606024-120178

ADDENDUM NO. 3

**Federal Aid Project No. STP/HPP/CMQ-0035(015)X
Roadway Reconstruction and Related Work (Including Signals)
on a Section of Route 44 (Dean Street)**

<u>QUESTIONS AND RESPONSES:</u>	2 pages.
<u>DOCUMENT 00010:</u>	Revised page 3.
<u>DOCUMENT 00104:</u>	Revised page 3.
<u>DOCUMENT 00813:</u>	Deleted document in its entirety and inserted new document (4 pages).
<u>DOCUMENT 00880:</u>	Deleted document in its entirety and inserted new document (12 pages).
<u>DOCUMENT A00801:</u>	Revised pages 24, 170, 171, 173, 174, 175, 196, and 235. Inserted new pages 24.1, 24.2, 147.1, 147.2, and 162.1 through 162.14.
<u>DOCUMENT B00420:</u>	Revised pages 3, 10, and 21 through 32. Removed pages 33 and 34.
<u>PLANS:</u>	Revised sheet Nos. 60, 113, and 123 of 185.

RIVERFRONT RESTORATION PLAN

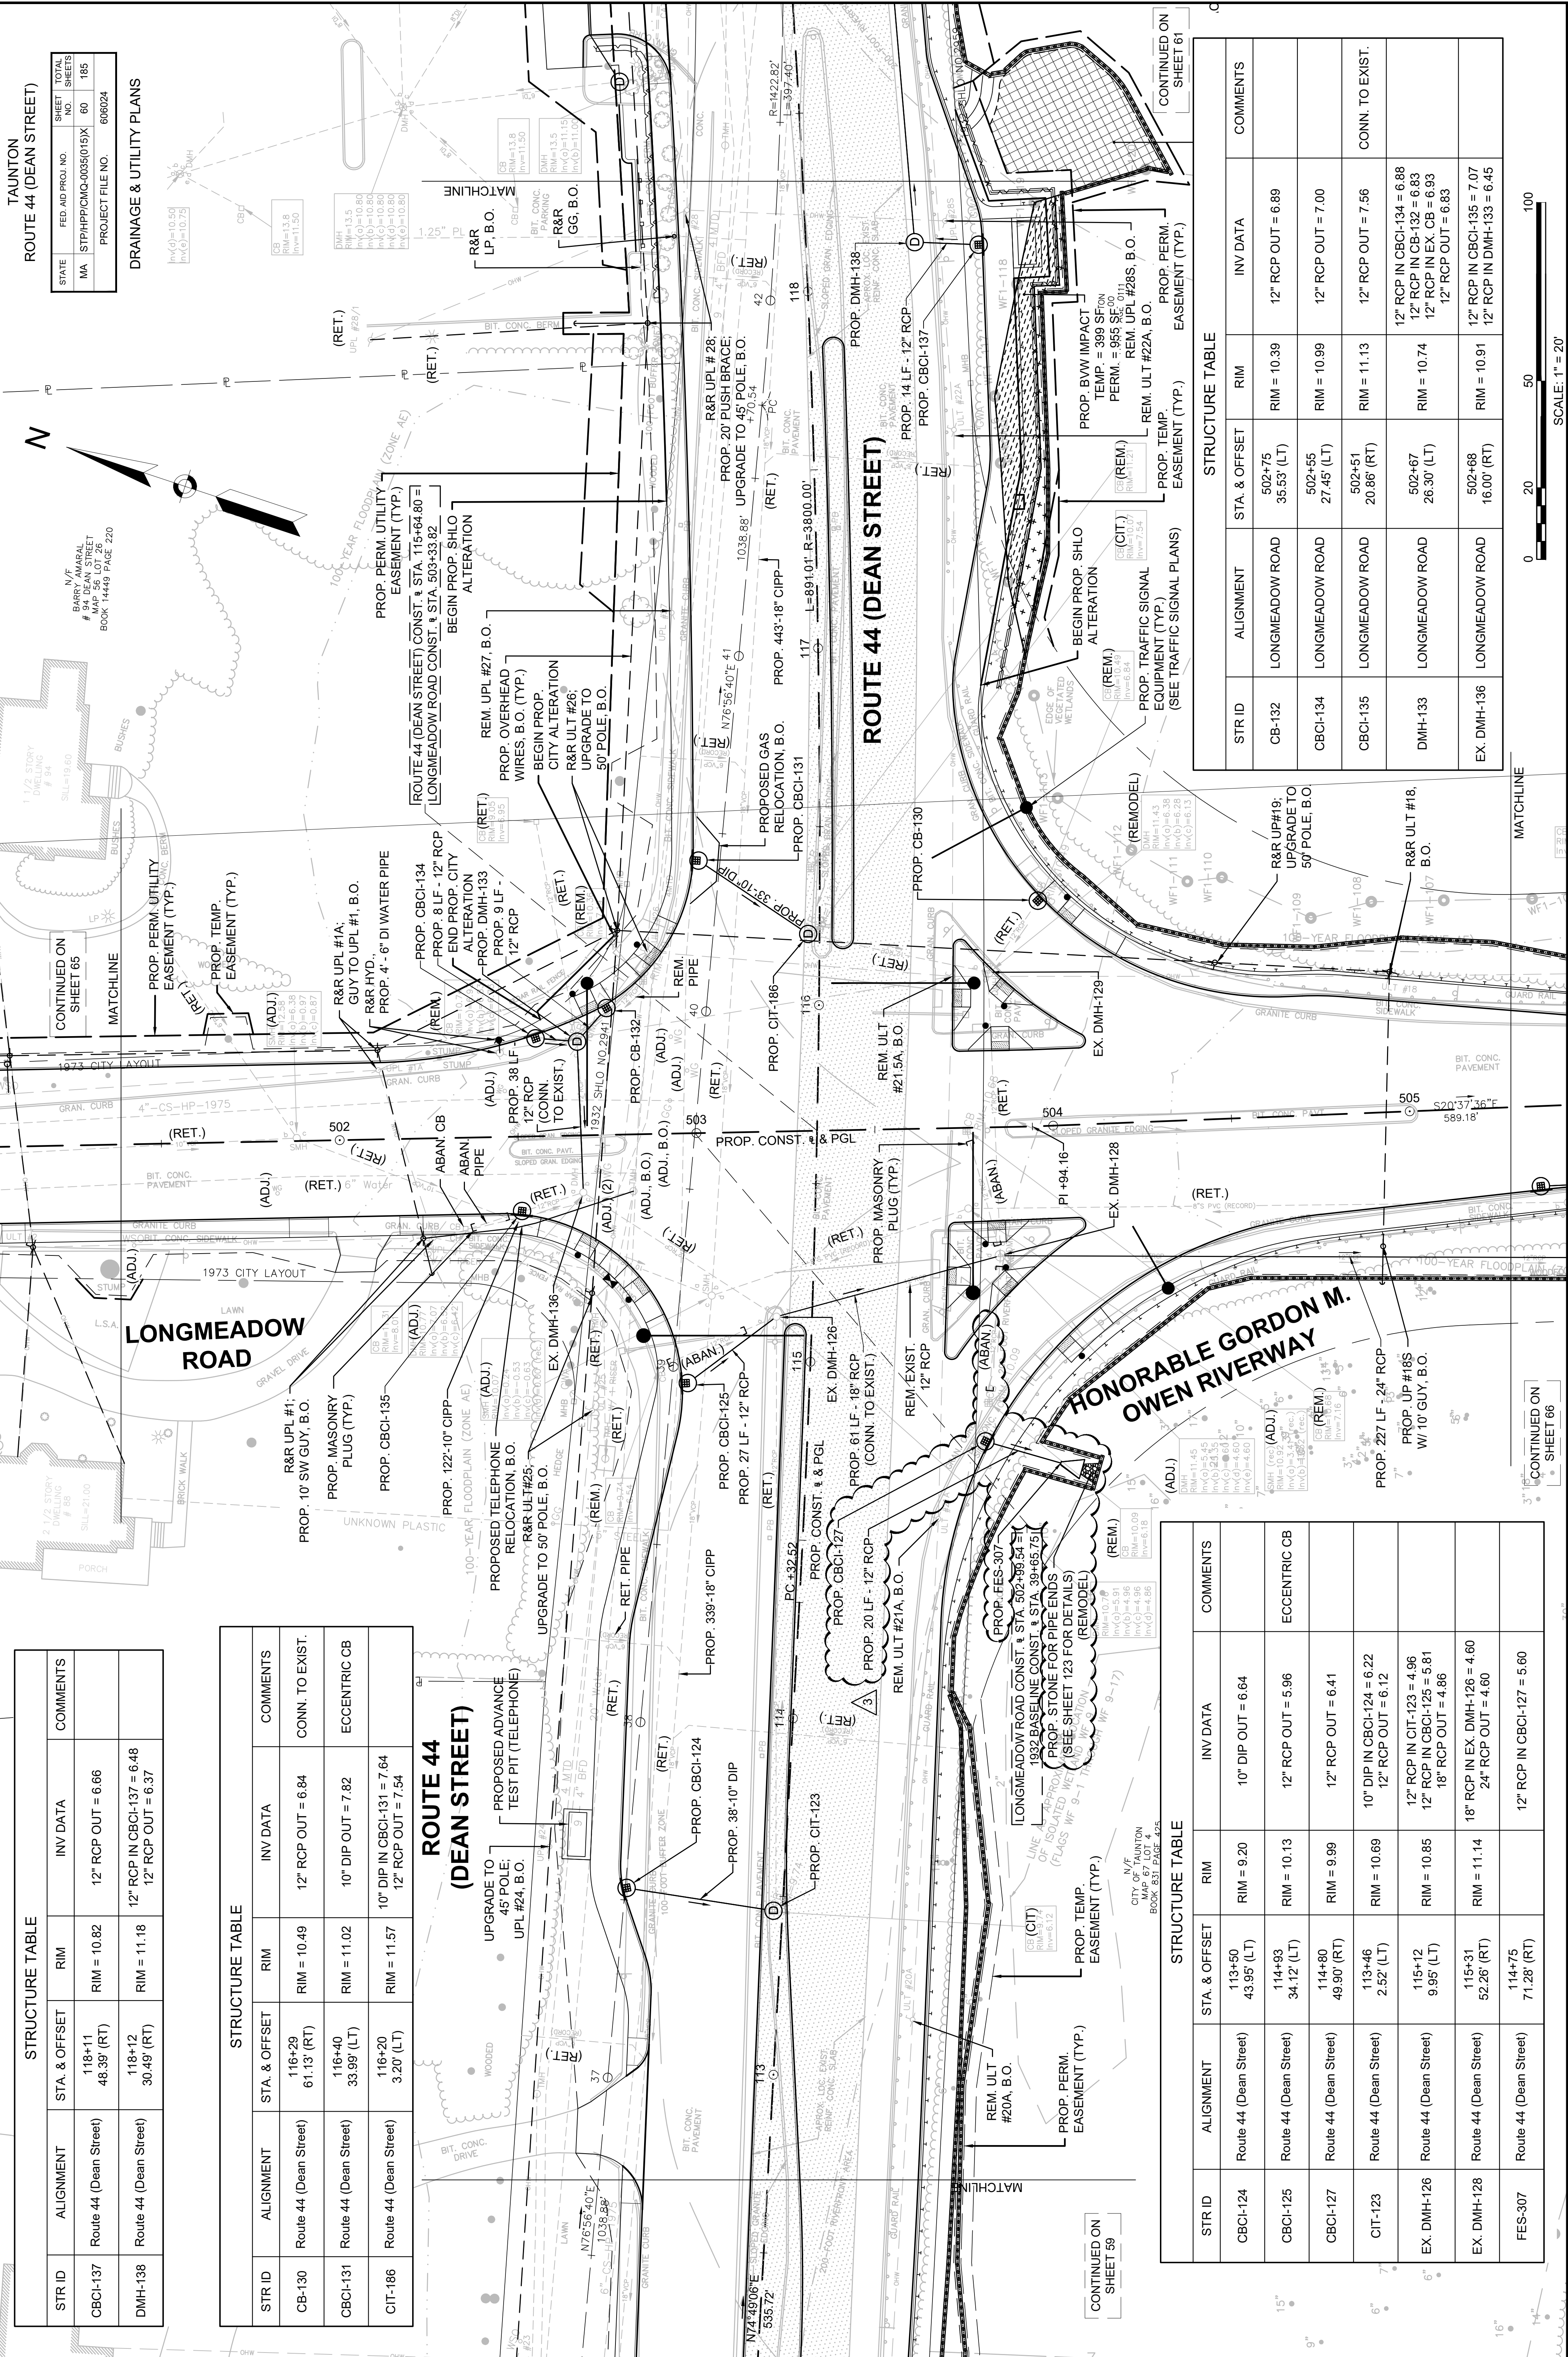
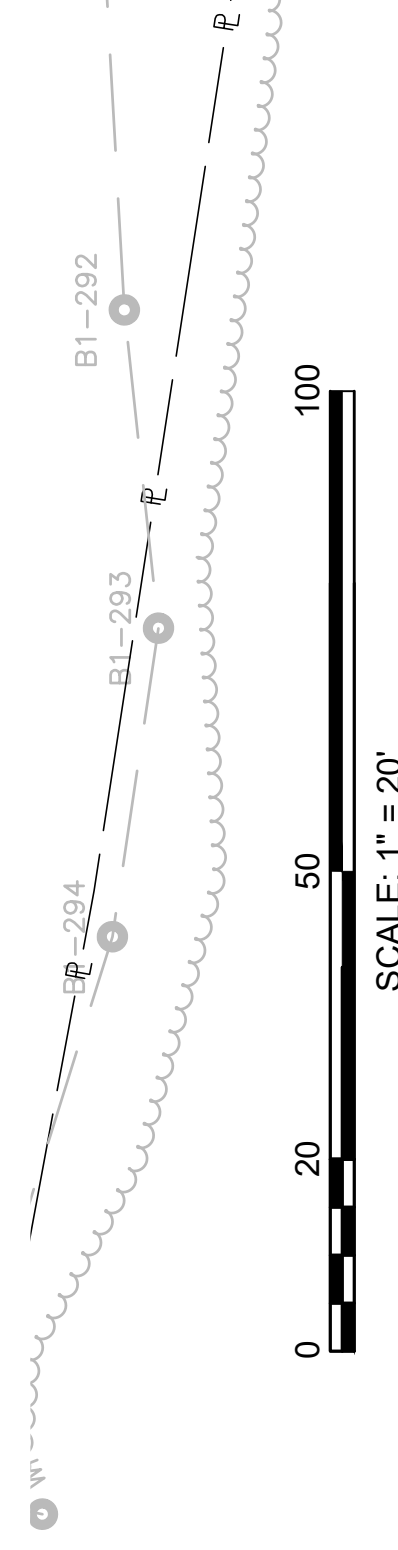
Question 11) Please provide a size and location for the offsite riverfront mitigation area. What will be required for contractor access to this offsite mitigation area? Is all work associated with the mitigation area to be paid under contract items?

Response 11) See revised pages A00801-162.1 through 162.14

- RIVERFRONT RESTORATION TO INCLUDE CONTROL OF INVASIVE PLANT SPECIES AND INSTALLATION OF NATIVE PLANTINGS WHERE APPLICABLE.
- INVASIVE PLANT CONTROL SHALL MINIMIZE IMPACTS TO EXISTING GRADES AS MUCH AS POSSIBLE. CARE SHALL BE TAKEN TO AVOID IMPACTS TO THE ROOT SYSTEMS OF EXISTING TREES.

- UNLESS NOTED OTHERWISE, ALL DISTURBED AREAS SHALL BE RESTORED WITH COMPOST AND PART SHADE RIVERBANK SEED MIX.
- IN GENERAL, INVASIVE PLANTS ARE EVENLY DISTRIBUTED THROUGHOUT THE SITE. THIS INCLUDES MULTIFLORA ROSE, ASIATIC BITTERSWEET, EUROPEAN PRIVET, BURNING BUSH, BUSH HONEYSUCKLE, & JAPANESE BARBERRY.

- SELECT AREAS WHERE HIGH CONCENTRATIONS OF INVASIVE PLANTS WERE FOUND ARE SHOWN ON THE PLAN ABOVE.
- THE ABUNDANCE OF INVASIVE PLANT SPECIES FOUND ON SITE PROHIBIT SHOWING INDIVIDUAL INVASIVE PLANT LOCATIONS ON THIS PLAN.

- PLANT LAYOUT SHOWN ABOVE IS CONCEPTUAL. WETLAND SPECIALIST SHALL LOCATE PROPOSED PLANTS WITHIN THE RIVERFRONT RESTORATION AREA AS APPROPRIATE TO BEST RESTORE DISTURBED AREAS.
